30th April 1883, No. 1262 W., Public Works.

GOVERNMENT OF MADRAS.

Horse Stables at Bellary

Royal Artillery Stables at St. Thomas' Mount

PLAN FOR COVERED STABLES.

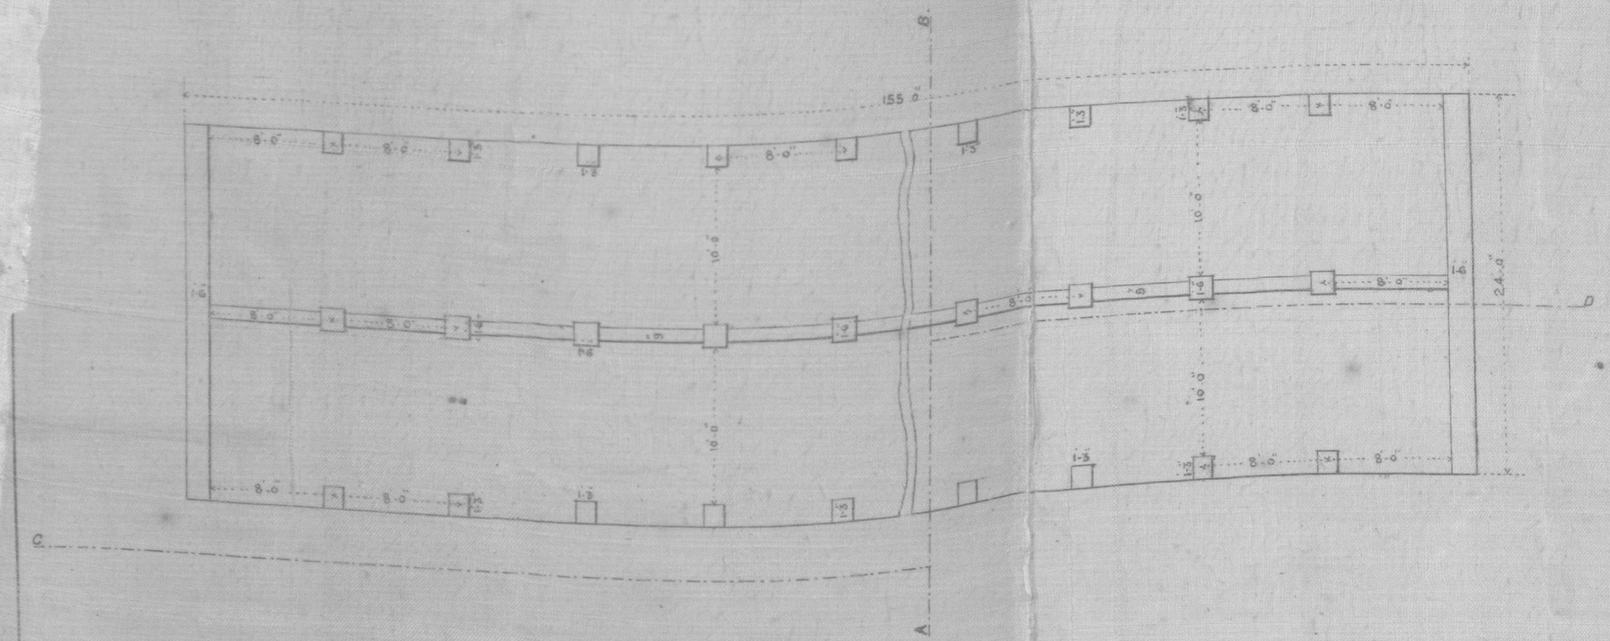
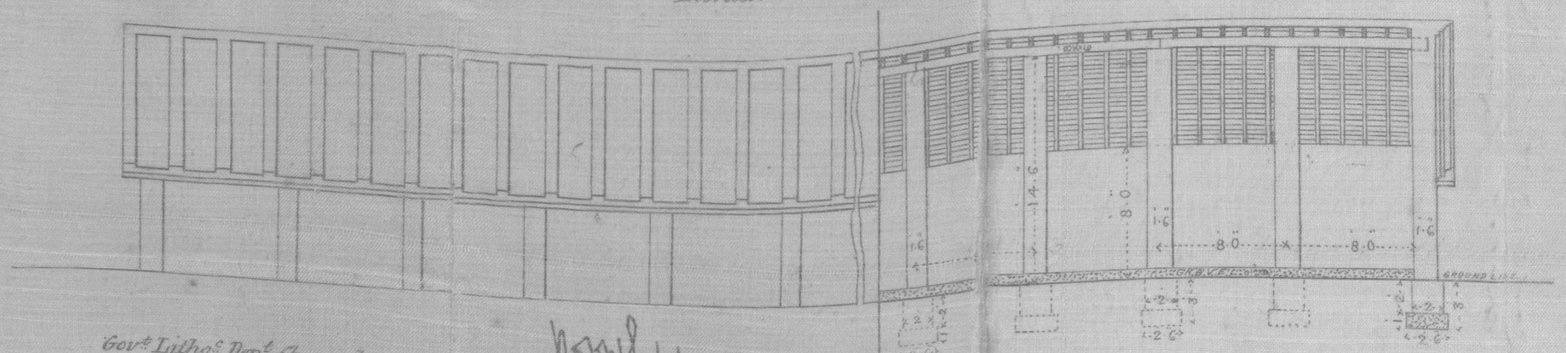
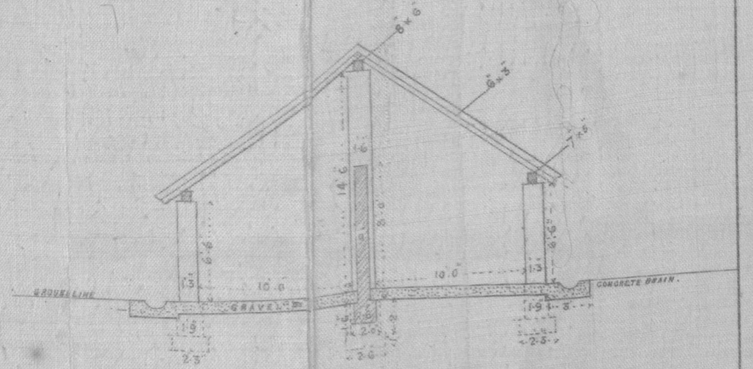
3. The stables at St. Thomas' Mount were constructed almost in accordance with the standard plan of 1883, but cross or partition walls 6 feet high and 9 inches thick, were added to strengthen the building. The Executive Engineer, Chingleput division, reports that these cross walls "were removed by the Military Department, and, as far as can be ascertained, without the consent of the Public Works Department."

4. Taking into consideration the broadside collapse of the building, the Chief Engineer has no hesitation in saying that the accident was mainly due to the removal of the cross walls, which would have constituted a material support to the outer and middle pillars. It is probable that the walls were removed in order to make the stables more airy and commodious, and no doubt that object was fully attained, but taking into consideration the weight of the tiled roof, it is evident that without support the pillars on which it rested were very liable to become unsettled on any unusual lateral pressure being applied to them.

5. It therefore appears to the Chief Engineer that the standard design and specification of 1883 are defective in that no cross walls are provided, and he would recommend that they be revised accordingly.

Communicated to the Military Department for information and for favor of remarks with special reference to the recommendation made in para. 5 of the Chief Engineer's note.
